Architect's Supplemental Instructions

Architect's ASI No: 036

Project:
Webster University
Interdisciplinary Science
Building

Discipline Code: 03 Electrical

E0102.A

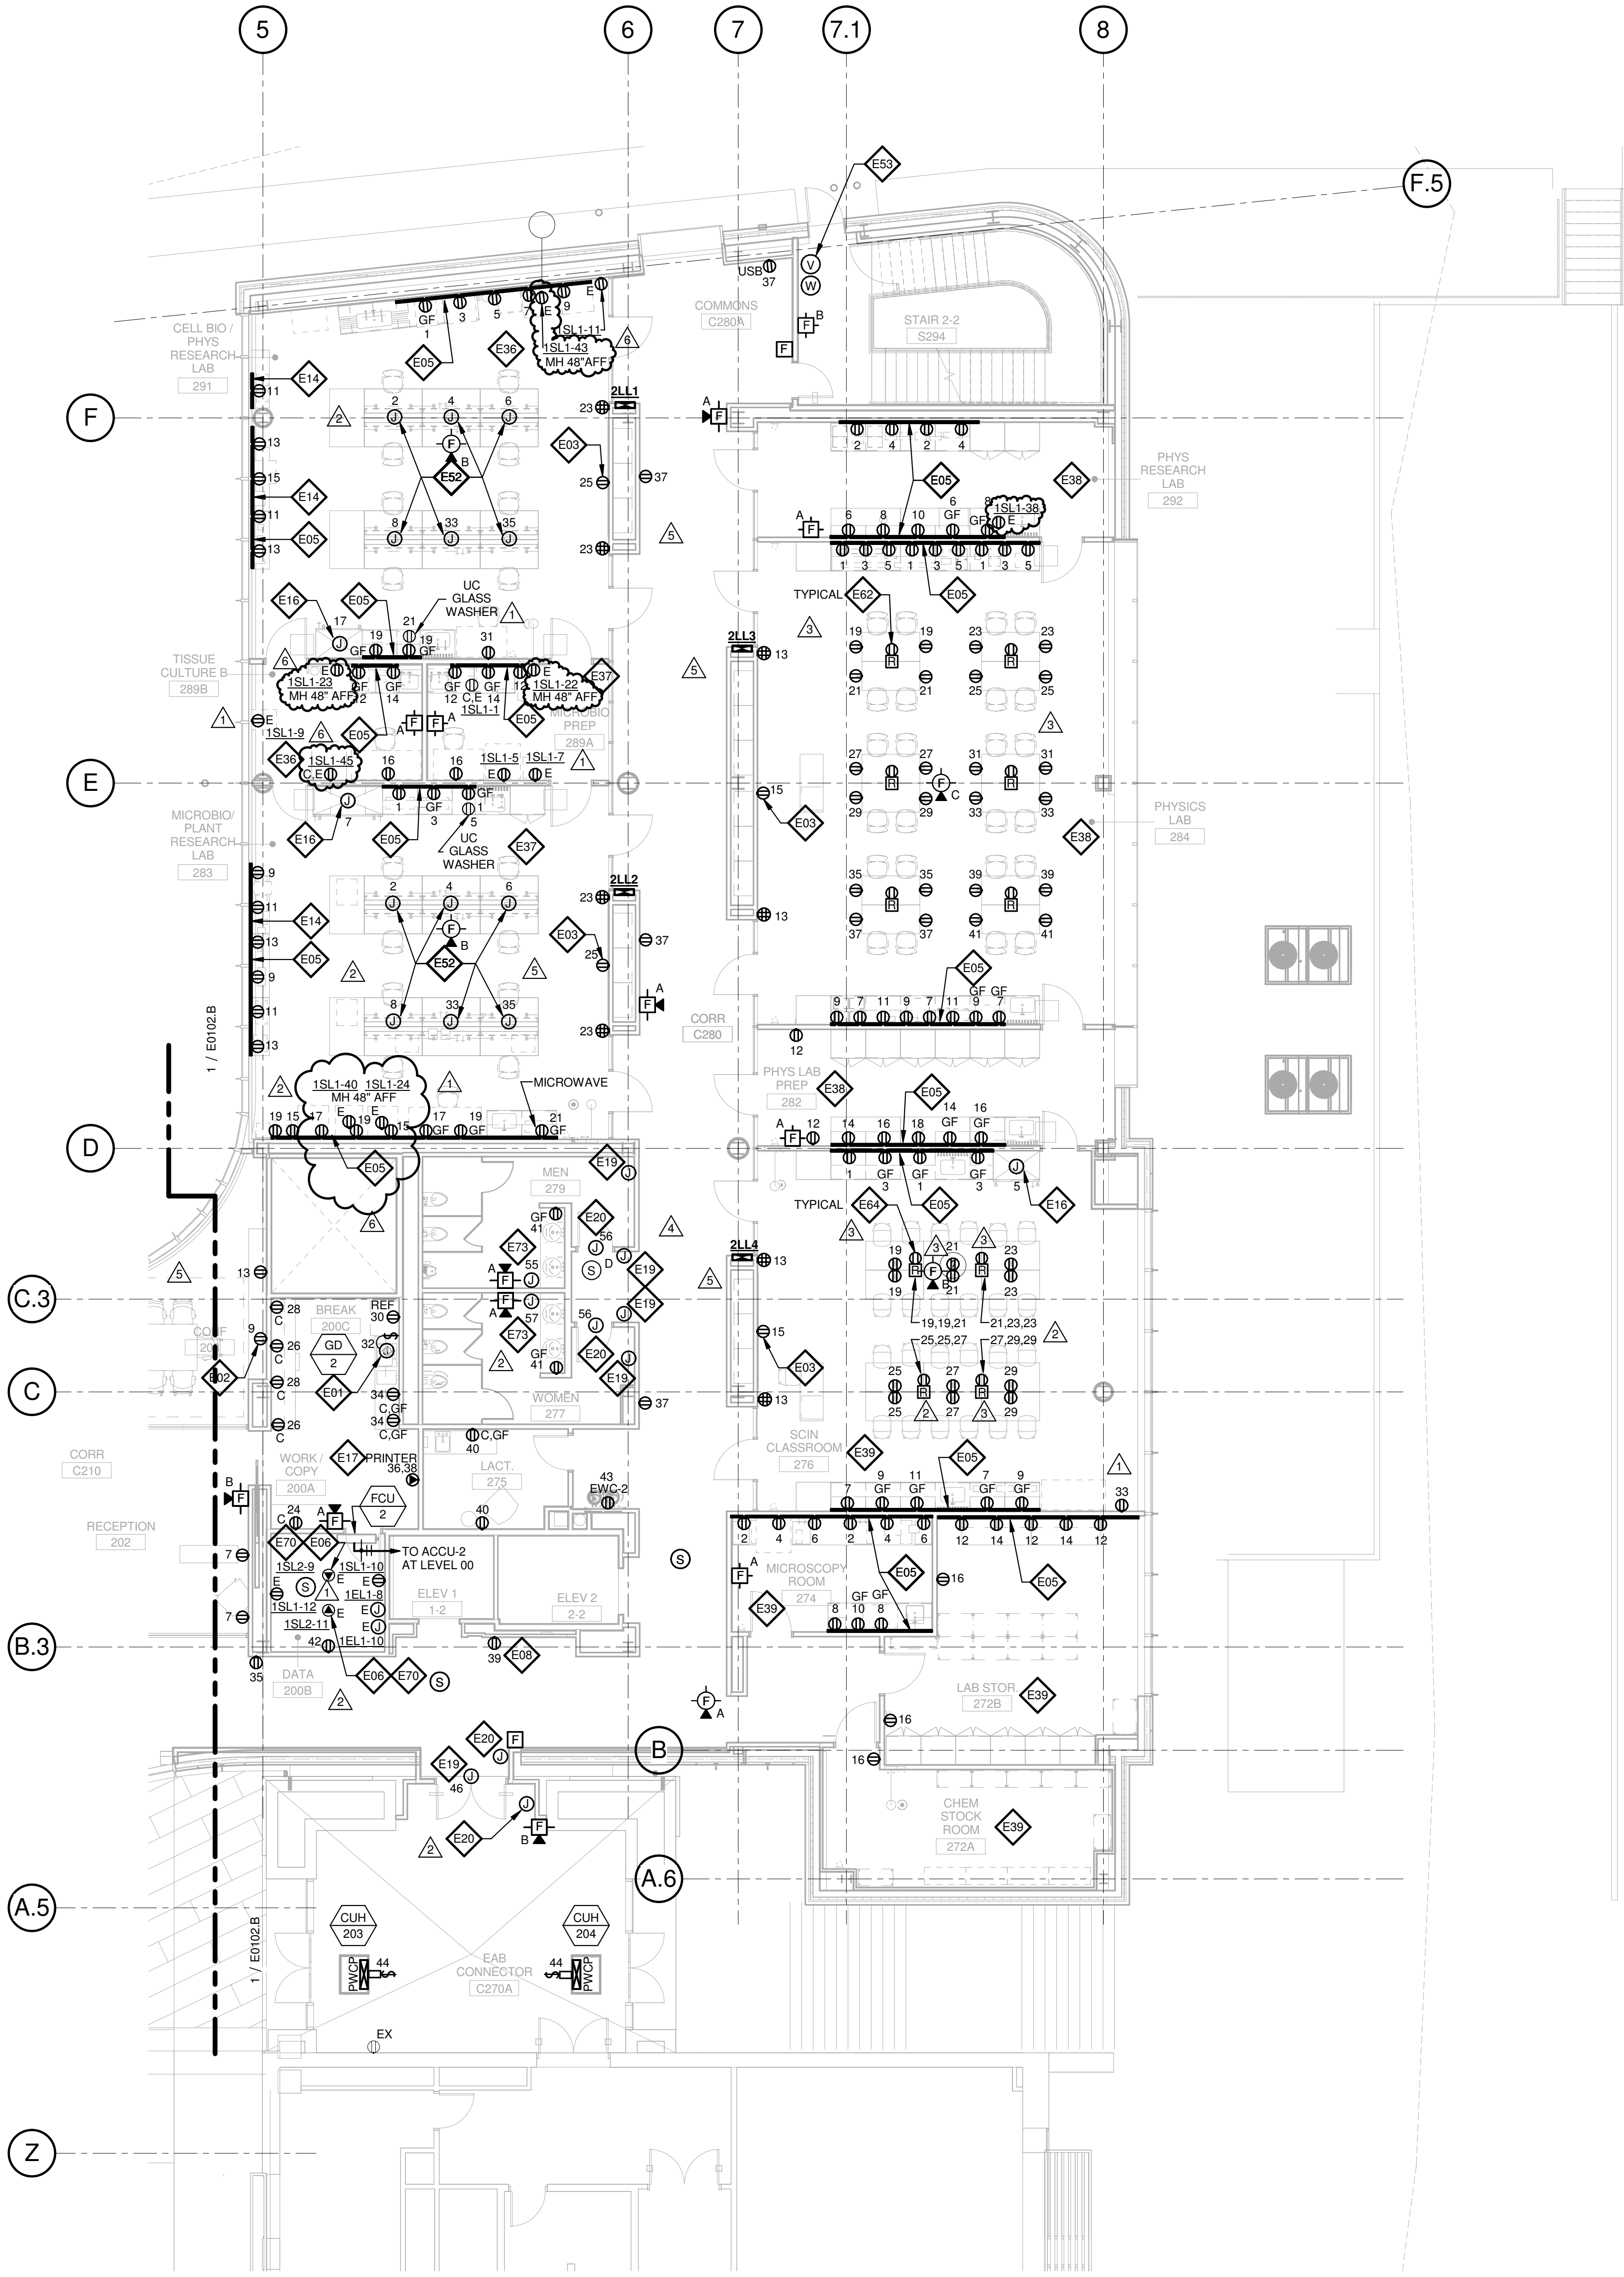
SHEET E0102.A LEVEL 02 AREA A FLOOR PLAN – ELECTRICAL

- In room 291, provide emergency power for Deli Refrigerator and connect to 1SL1-43.
- In room 289B, connect refrigerator to emergency power circuit 1SL1-23. Delete branch circuit 20 previously serving equipment.
- In room 289B, connect incubator to emergency power circuit 1SL1-45. Delete branch circuit 18 previously serving equipment.
- In room 289A, connect refrigerator/freezer to emergency power circuit 1SL1-22. Delete circuit 18 previously serving equipment.
- In room 292, provide emergency power for under counter refrigerator and connect to 1SL1-38.
- In room 283, provide emergency power for freezer and connect to circuit 1SL1-24.
- In room 283, provide emergency power for refrigerator and connect to circuit 1SL1-40.

E0102.B

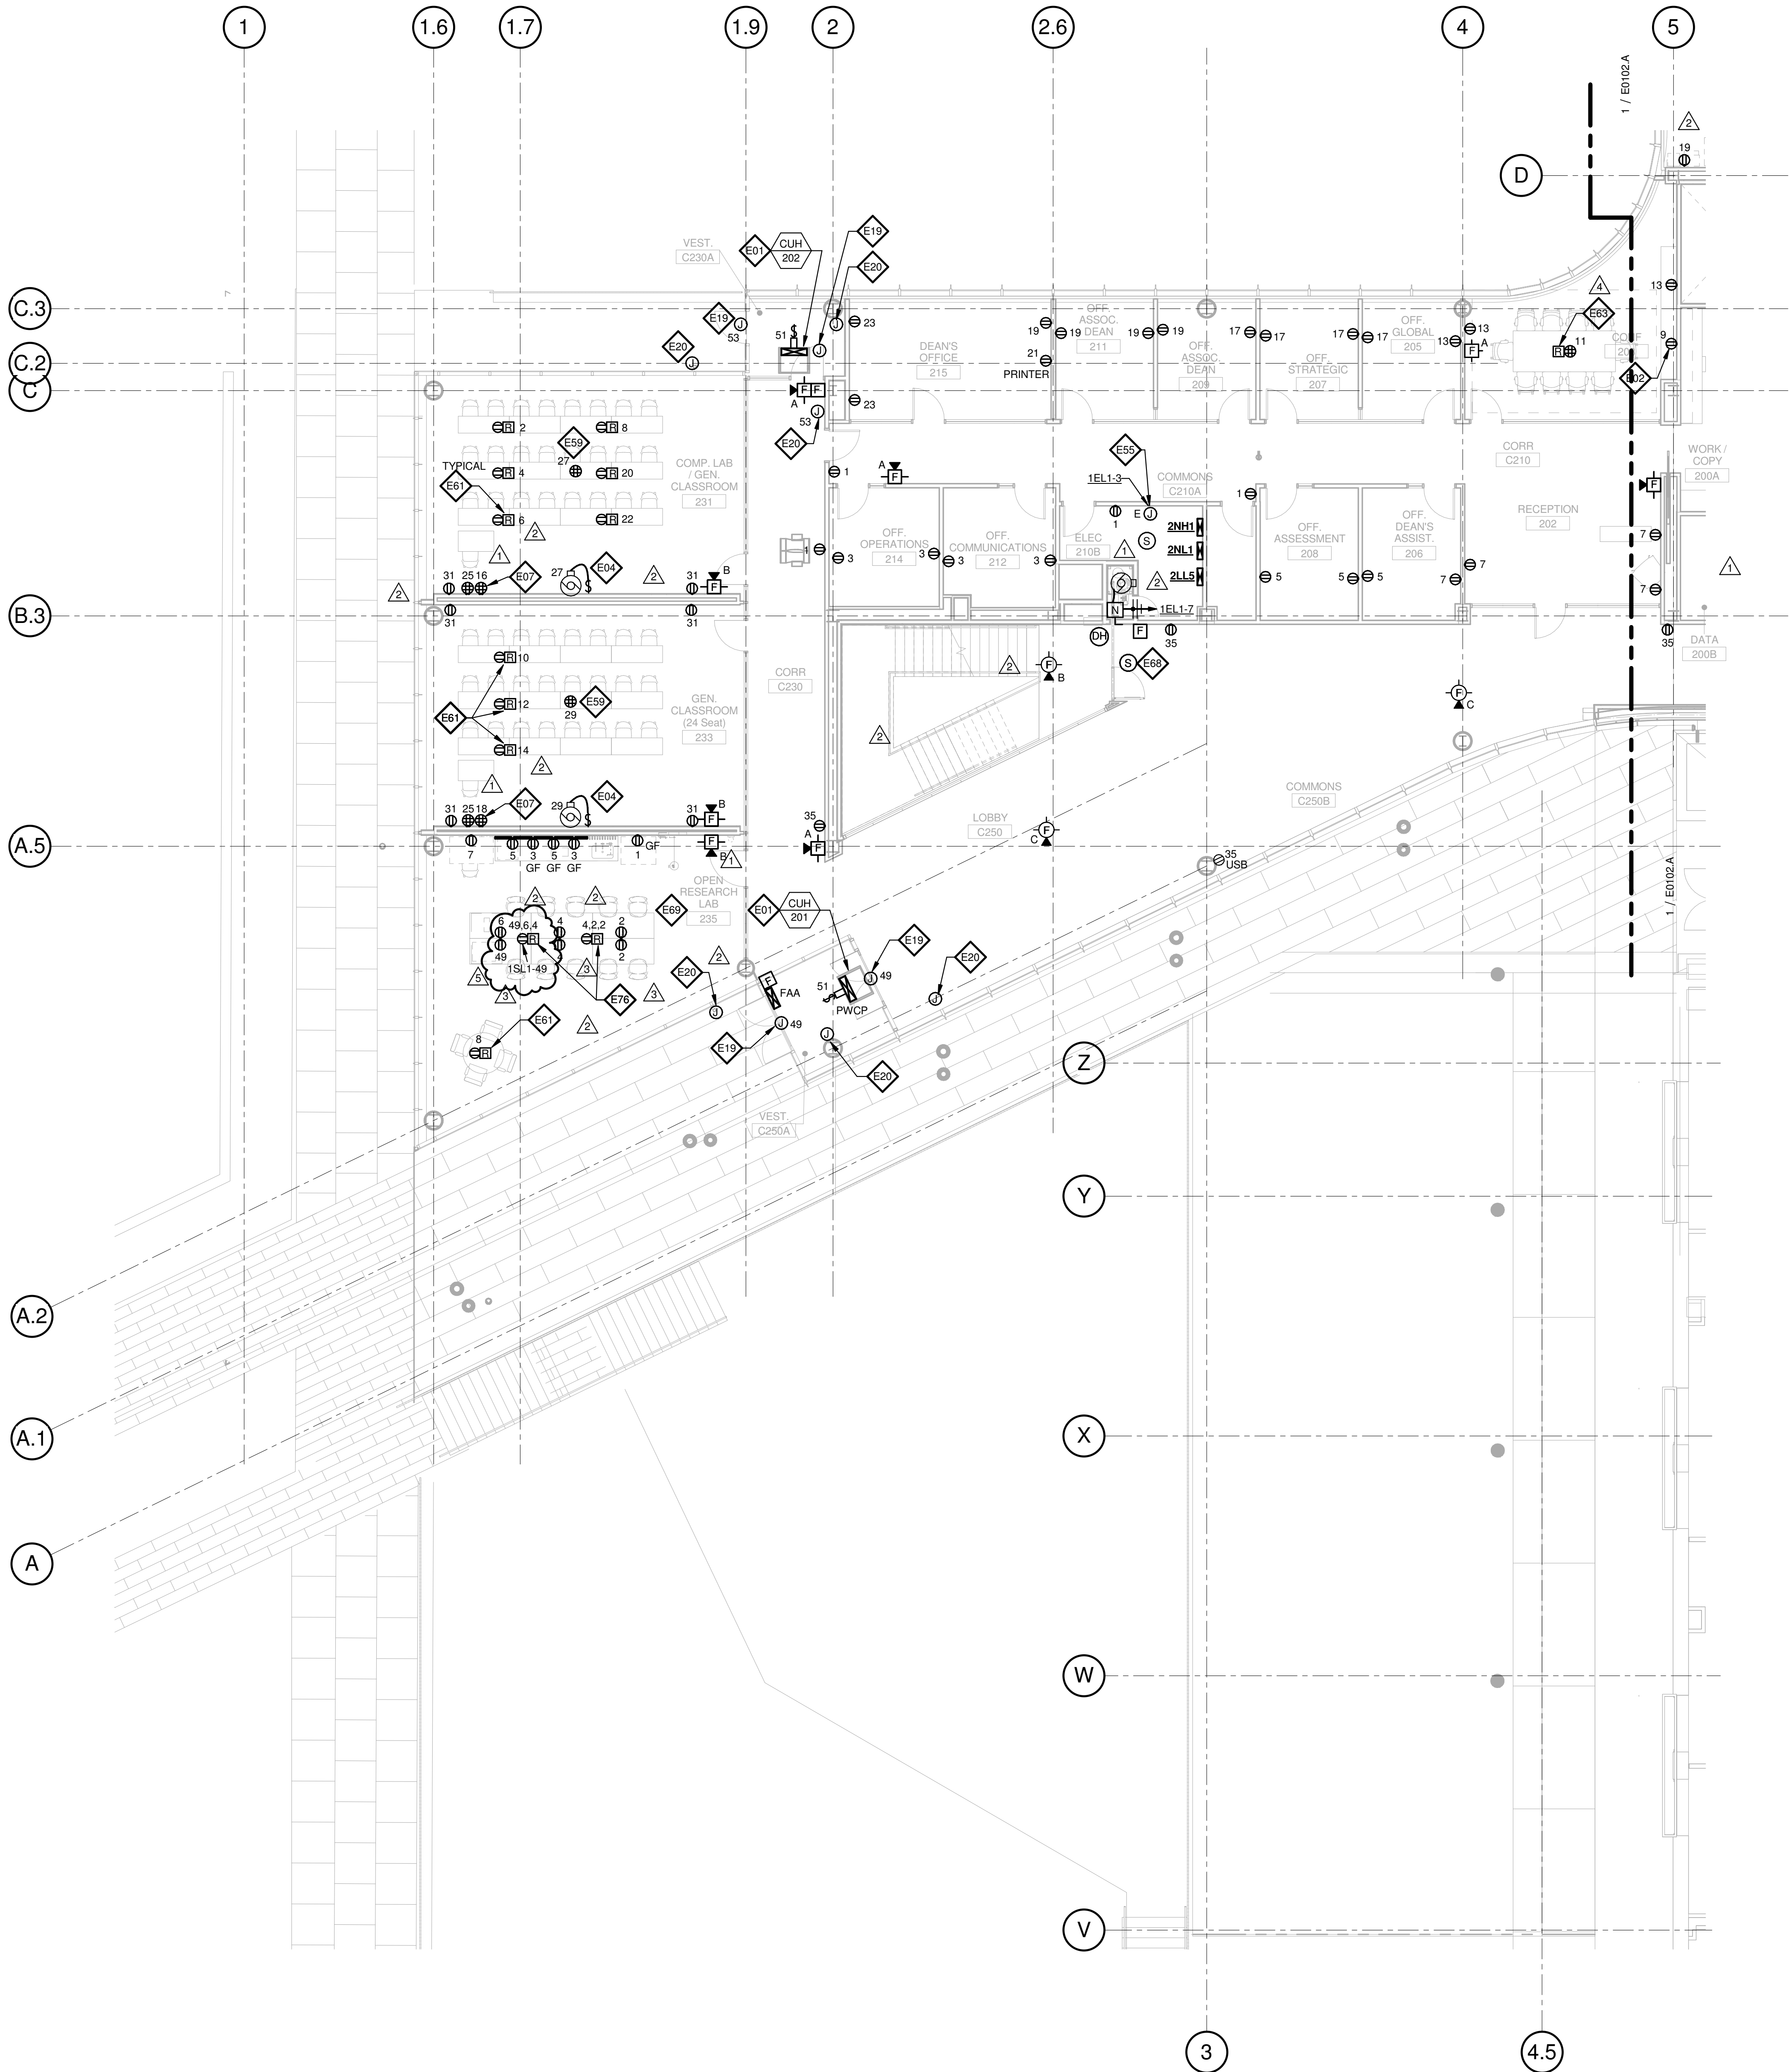
SHEET E0102.B LEVEL 02 AREA B FLOOR PLAN – ELECTRICAL

- In room 235, extend circuit 1SL1-49 to receptacle in floor box to serve MySeq System.
